**SOUTH PLANNING COMMITTEE
SCHEDULE OF ADDITIONAL LETTERS**

Date: 22nd July 2014

Item No.	Application No.	Originator:
5	13/03862/OUT	Applicant

Ludlow Access briefing note

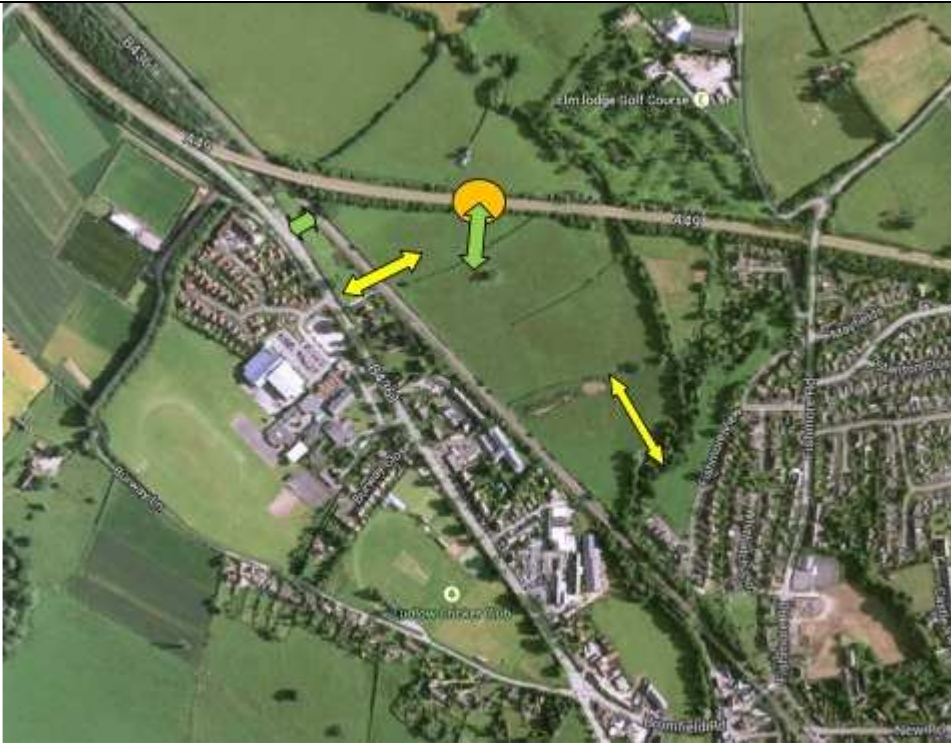
It has two vehicle access points for the two development areas, off the A49 shown as an amber circle and Broomfield Road respectively with green arrows.

It also has two pedestrian and cycle routes shown in yellow, the key connection across the rail line to Broomfield Road and one across the River Corse to the open area/residential area to the SE.

Vehicle access Traffic surveys of the A49 and Broomfield Road junctions were undertaken in the peak periods, daily/weekly flows on the A49 along with the speeds of the vehicles. The A49 access is the primary access off the trunk road network, extensive meetings and discussions with the HA to ensure the scale of the roundabout was appropriate for the traffic flows

The HA have a detailed process to agree new junctions on the system including st lighting and traffic sign design, landscape and visual impacts, safety reviews and road markings to ensure the scheme can be approved and the design is deliverable with no associated safety or design issues.

The preliminary design was subject to a safety audit and the feedback used to improve the design and add further detail. The revised design was then also subject to a further safety audit to no outstanding concerns were raised, the roundabout access has been agreed as a safe junction for the scheme to use.

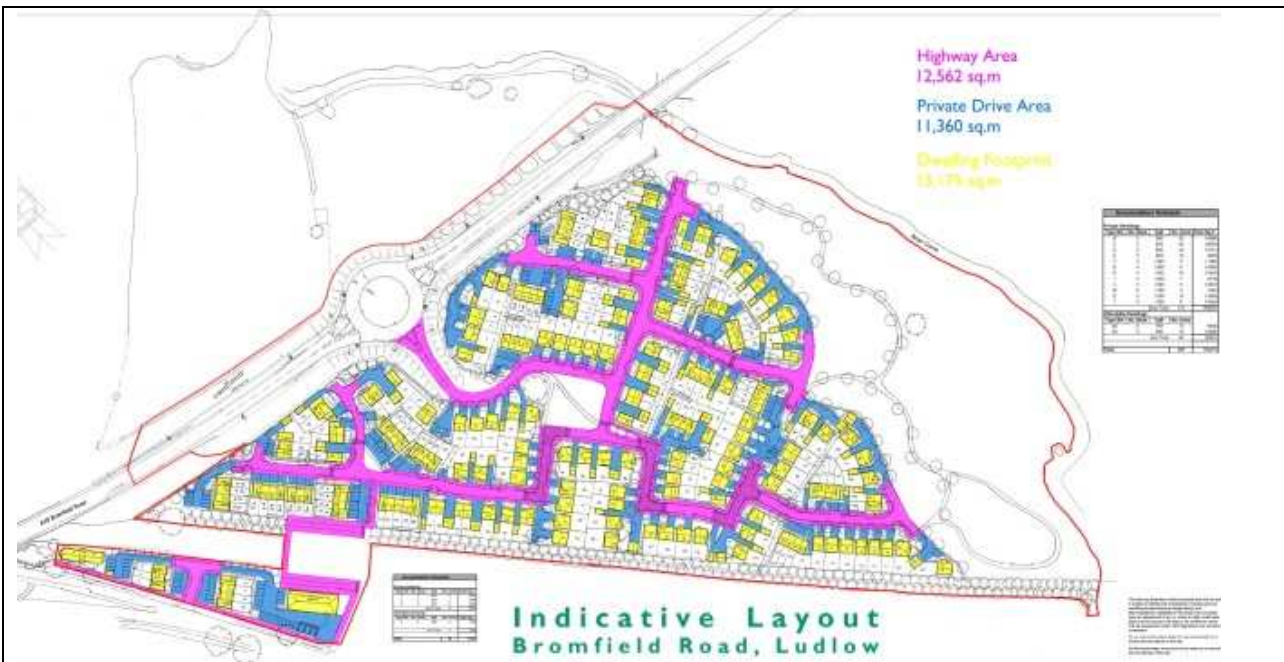
Item No.	Application No.	Originator:
5	13/03862/OUT	Applicant
<p>The applicant's drainage consultant has submitted an outline surface water strategy which highlights existing drainage commitments in the application. The conclusions indicate that appropriate sustainable drainage solutions are available and are capable of being progressed at the reserved matters stage:</p> <ol style="list-style-type: none"> 1) The options in order and to be investigated further are: <ul style="list-style-type: none"> <input type="checkbox"/> Disposal of all surface water to ground via infiltration techniques. <input type="checkbox"/> Partial disposal of surface water to ground in priority of private driveways using permeable paving systems; roof drainage using soakaways and carriageway using permeable paving systems. <input type="checkbox"/> Partial or complete discharge to watercourse with limited discharge and on-site storm attenuation as required in the form of large diameter trunk drains and / or offline tank storage. Attenuation could also be incorporated in rainwater harvesting tanks. 2) It should be noted that the layout should only be finalised after the drainage has been designed to ensure sufficient space is allowed for soakaways and / or attenuation. 3) A possible scenario for the controlled disposal of Surface Water can be found in Appendix C which can be used for guidance. 4) Design the size of the soakaways for roof drainage, design the permeable paving for private driveways and consult the highway authority to agree a sustainable highway drainage method.

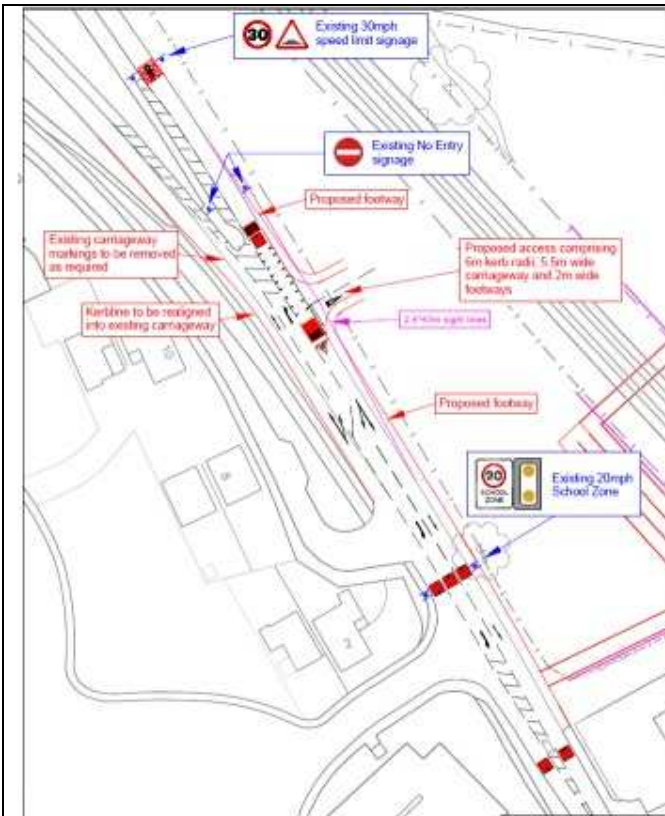
The applicant has confirmed the layout of the proposed roundabout on the A49 and that this has been agreed in principle by the Highways Agency. A vertical alignment plan has also been provided and will be made available at the committee site visit:

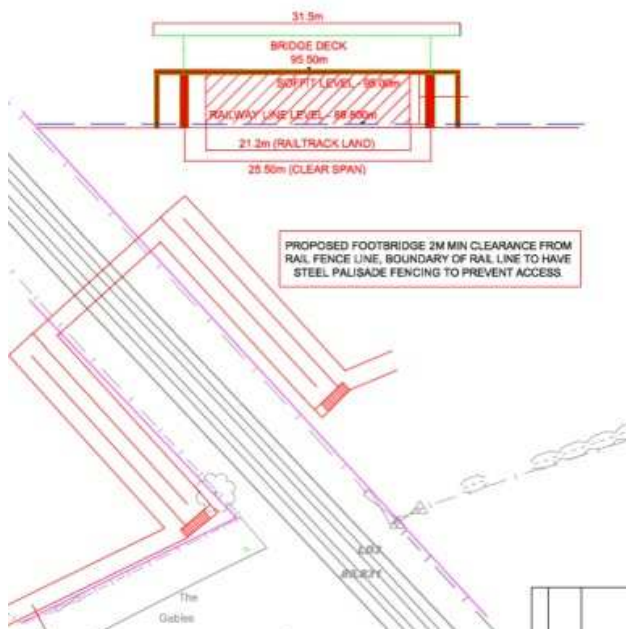
The applicant has provided a plan showing the details of the pedestrian footbridge over the railway line at Bromfield Road.
